**From:** [Diane Boone](#)  
**To:** [West, Andrea](#)  
**Cc:** [Abaied, Sharmaine](#); [COUNCIL](#); [Ehrman, Paul S](#); [Gallagher, Michael](#); [Guy Paolozzi](#); [Petkac, Cindy](#); [Town Manager](#)  
**Subject:** Re: BAR Consideration of Flagship Lighting Issue Proposal  
**Date:** Tuesday, March 17, 2020 1:00:37 PM

**From:** Diane Boone <[dianboon@gmail.com](mailto:dianboon@gmail.com)>  
**Sent:** Wednesday, January 15, 2020 10:56 PM  
**To:** West, Andrea  
**Cc:** Ehrman, Paul S; COUNCIL; Petkac, Cindy; Gallagher, Michael; Town Manager; Guy Paolozzi  
**Subject:** BAR Consideration of Flagship Lighting Issue Proposal

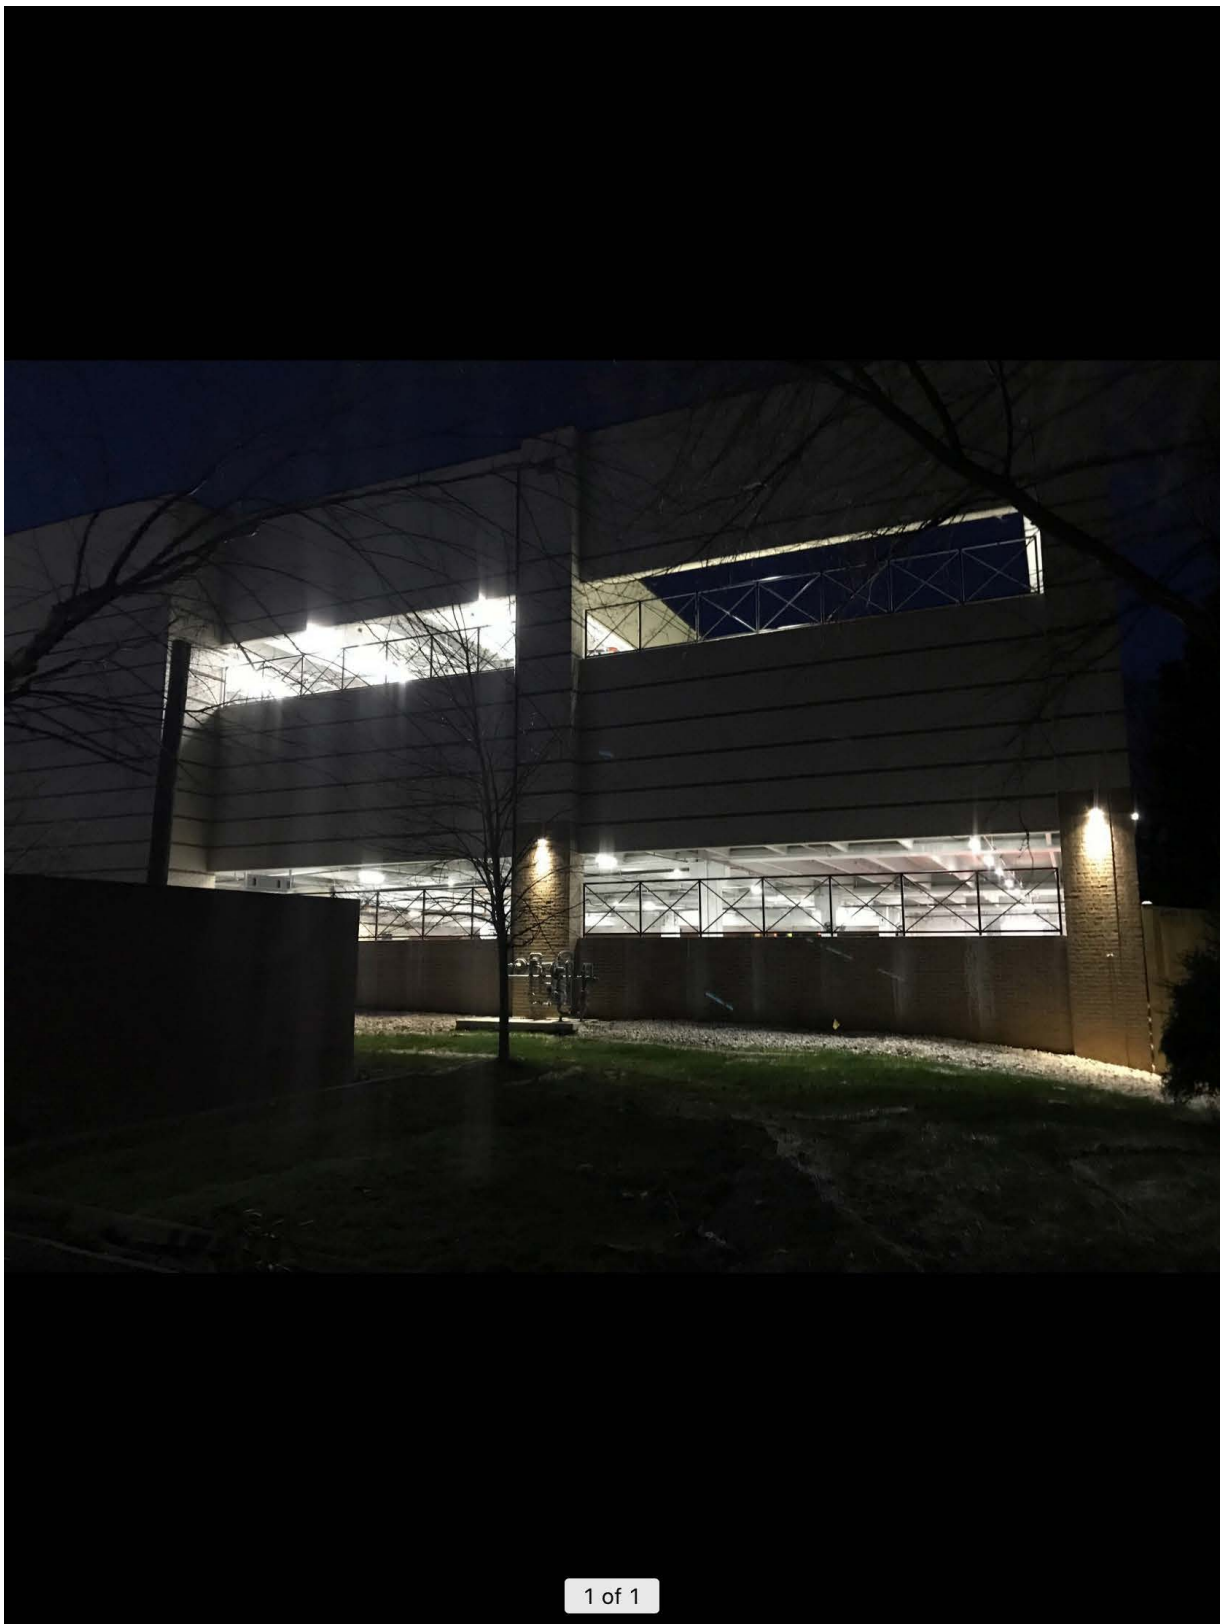
I would also again point out that we do not believe the current lighting meets the Town of Vienna restriction of 0.5 foot candles at our property line and also does not meet the Fairfax County Code for lighting either (which includes Glare restrictions). While addressing the second floor with the awning material will be helpful, we do not believe it will address the entire issue and bring the lighting within either the Town's or County's code - that will require some action regarding the first floor in addition to the second.

The photo included in the package for BAR discussion (see attachment) represents the issue well. Note that our property line is only 10 feet from the rear of the building and the interior lighting spills back towards our property. The lighting mounted on the exterior walls is as expected - it faces down rather than out. Also note that for parking garages (which Flagship's first floor, in particular, really is), Fairfax County has requirements for items such as "full cut off lighting" and lighting temperature.(leaning towards the yellow end of the spectrum vs white) rather than the type of lighting Flagship has.
